UNIT: # 501502
DEALER: Desert Autoplex
SPECIAL: # 1841

NEWMAR CORP P.O. Box 30, Nappanee, IN. 46550 UNITS: INCHES TITLE BLOCK: 3125TB	Model:	(K674)(K672)	Sheet	Drawn by:	Checked by:	Revision:	By:
		LA DP 4519	1 OF 1	Z. R.	A. M.		Date:
	Title:	FLOOR PLAN	I.D. # 2017\	Date:	Date:	Revision:	By:
			SPECIALS\MOT\	3/14/17	3/15/17		Date:
			1841FP

NEWMAR CORP P.O. Box 30, Nappanee, IN. 46550 UNITS: INCHES TITLE BLOCK: 75TB	Model:	Sheet	Drawn by:	Checked by:	Revision: Revised to show tile run horizontal due to CO #98027	By: Z. R.
	LA DP 4519	1 OF 1	Z. R.	A. M.		Date: 3/23/17
	Title:	I.D. # 2017\	Date:	Date:	Revision:	By:
	76 1/2 KITCHEN	SPECIALS\MOT\1841KT	3/10/17	3/15/17		Date:

2017 EX DP BACKSPLASH TILE

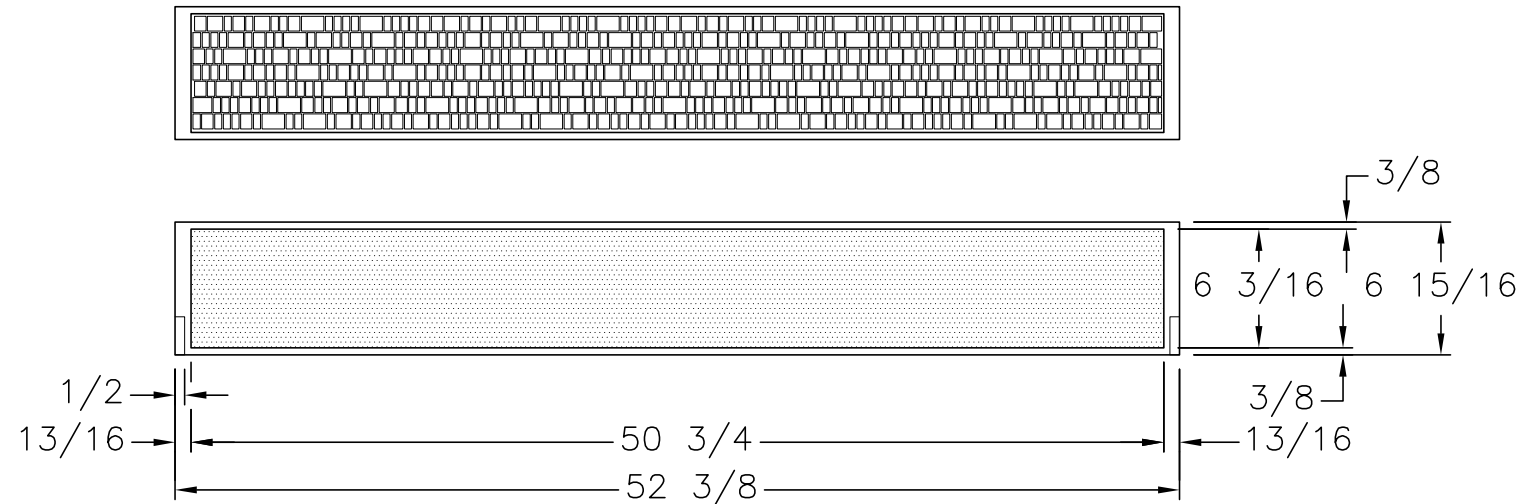
NEWMAR CORP P.O. Box 30, Nappanee, IN. 46550	Model:	Sheet	Drawn by:	Checked by:	Revision: Added EX DP sinks to print due to CO #98056	By: Z. R.
	LA DP 4519	2 OF 2	Z. R.	A. M.		Date: 3/22/17
	Title:	I.D. # 2017\	Date:	Date:	Revision:	By:
	LAV BASE & TOP	SPECIALS\MOT\	3/10/17	3/15/17		Date:
UNITS: INCHES		1841LV1				
TITLE BLOCK: 1TB

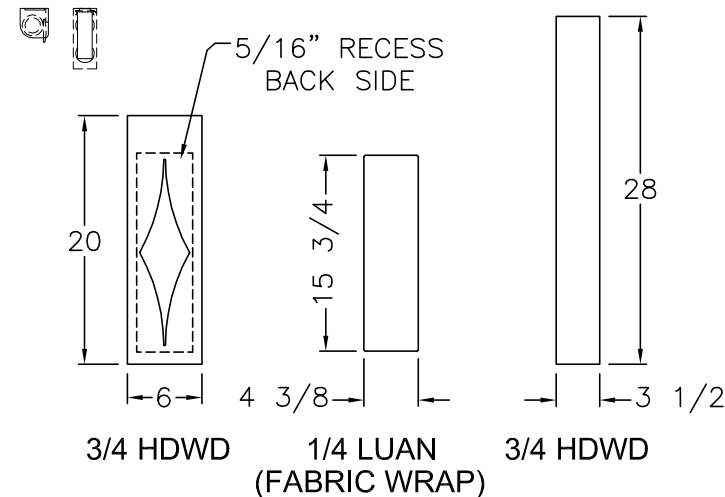
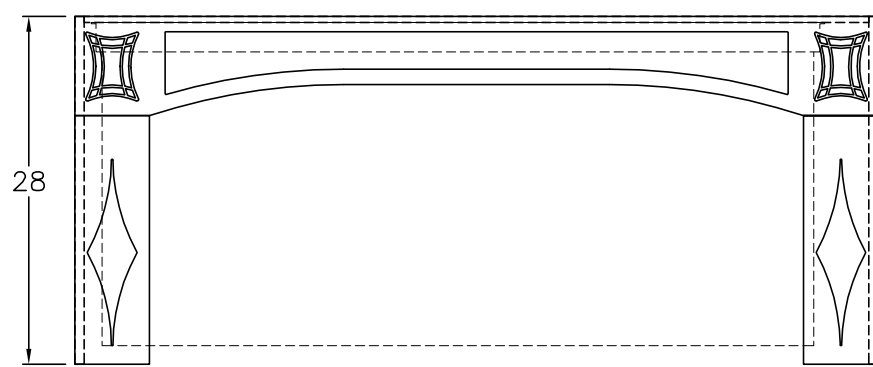
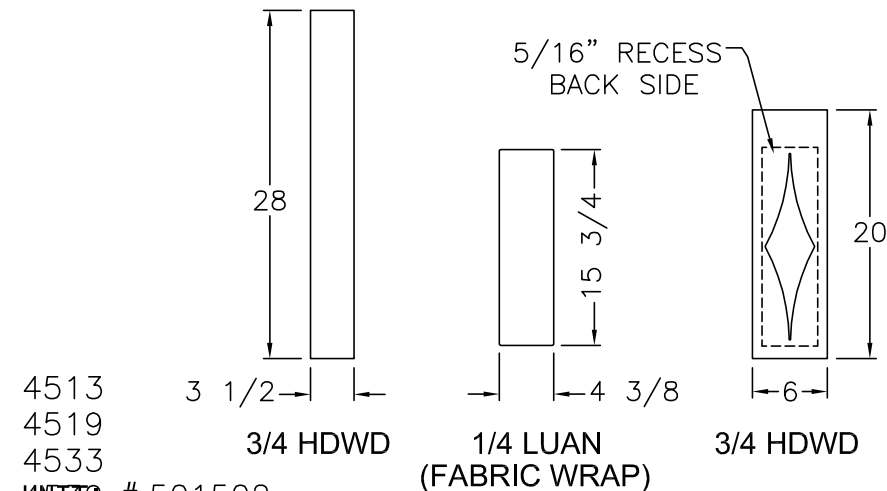
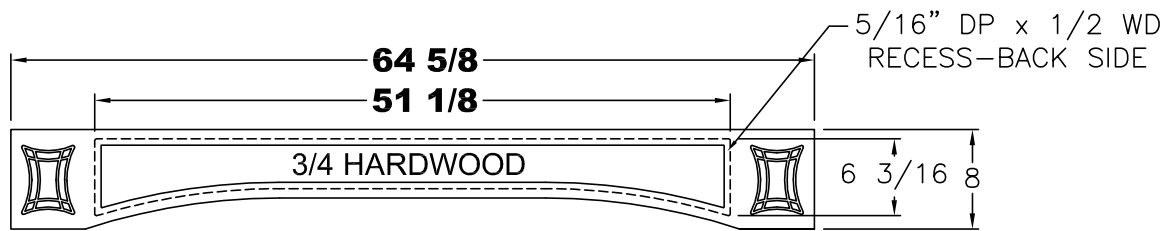
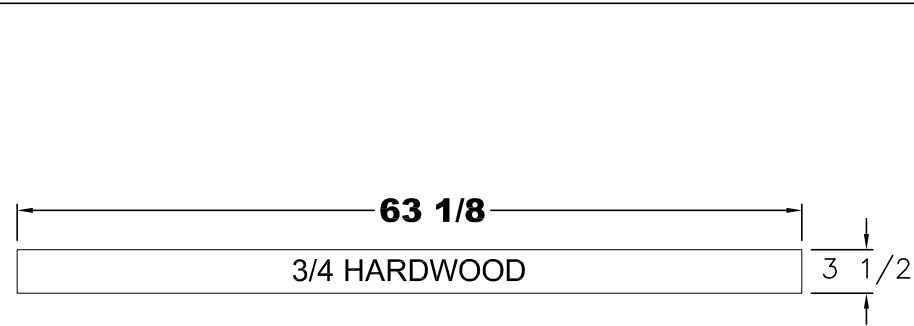
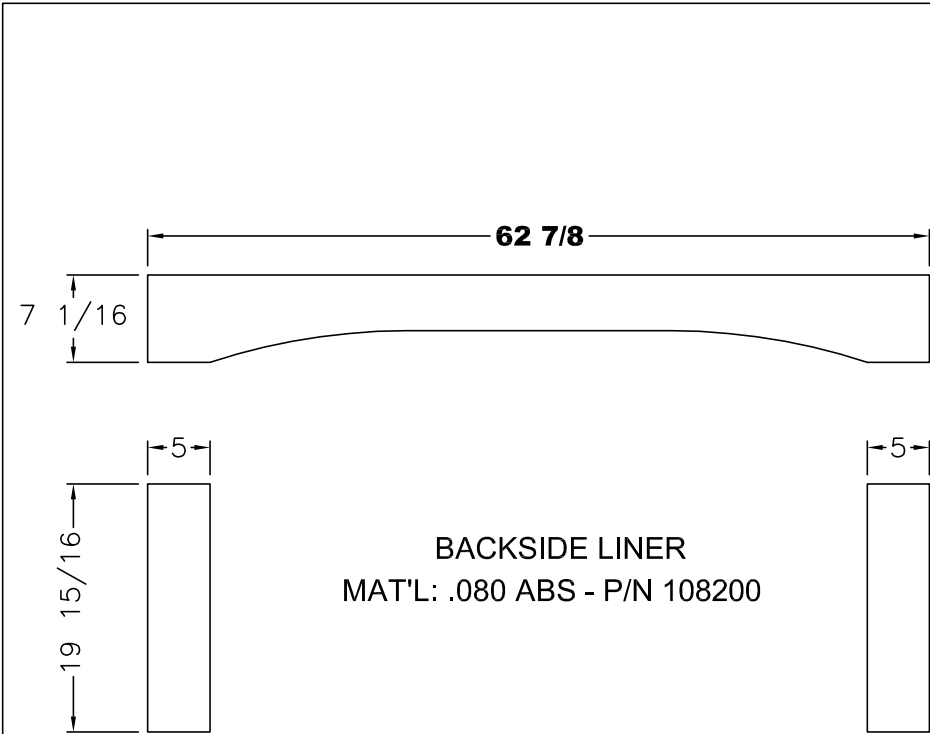
NEWMAR CORP <i>P.O. Box 30, Nappanee, IN. 46550</i>	Model: LA DP 4519	Sheet 1 OF 1	Drawn by: Z. R.	Checked by: A. M.	Revision: ADJUSTED PRINTS PER PRODUCTION BUILD. OK'D PER JEFF LAKE	By: A. M.
	Title: 57x24 LIVINGROOM WINDOW VALANCE	I.D. # 2017\ SPECIALS\MOT\ 1841VAL_6024	Date: 5/12/17	Date: 5/12/17	Revision:	Date: 5/12/17
	UNITS: INCHES					By:
	TITLE BLOCK: 1-5TB					Date:
